# WELDING INSPECTION REPORT

**Report No:** WIR-010173
**Date Inspected:** 26-Oct-2009

**Project Name:** SAS Superstructure
**Prime Contractor:** American Bridge/Fluor Enterprises, a JV
**Contractor:** Zhenhua Port Machinery Company, Ltd (ZPMC), Changxing Island

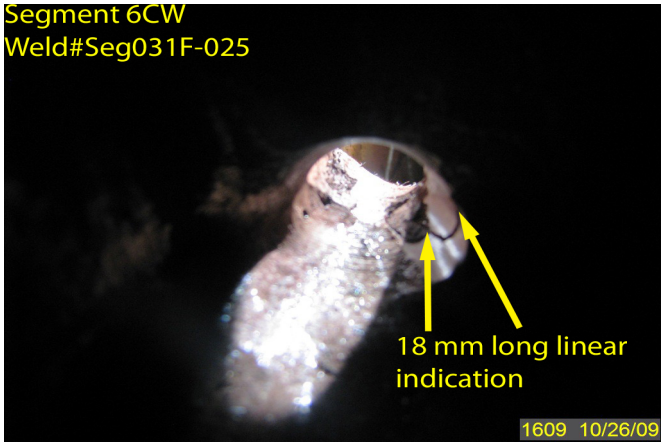
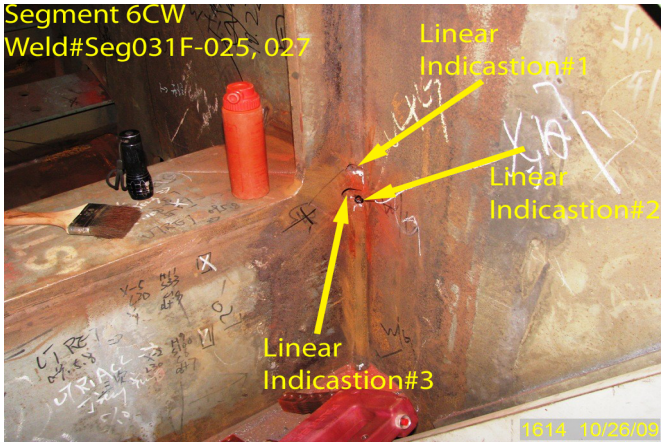
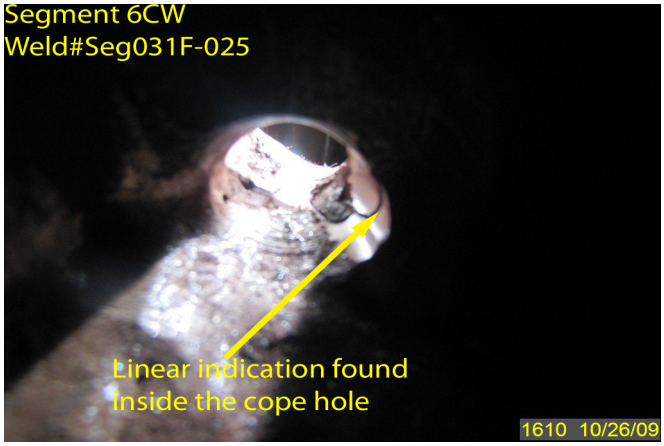
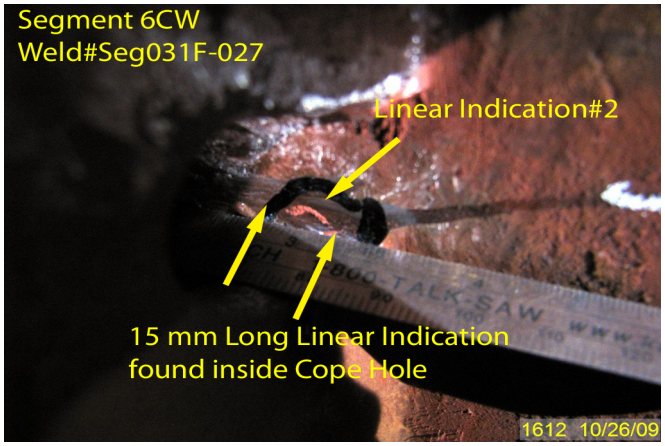
Caltrans Quality Assurance Inspector found three (03) Rejectable Indication inside the cope hole in segment6CW, weld#Seg031F-025 (18mm in length) and Seg031F-027 (two indications having 15 and 12 mm in length) during 10% Magnetic Particle Testing on the weld previously inspected and accepted by ZPMC. For further information, please see the attached pictures below.
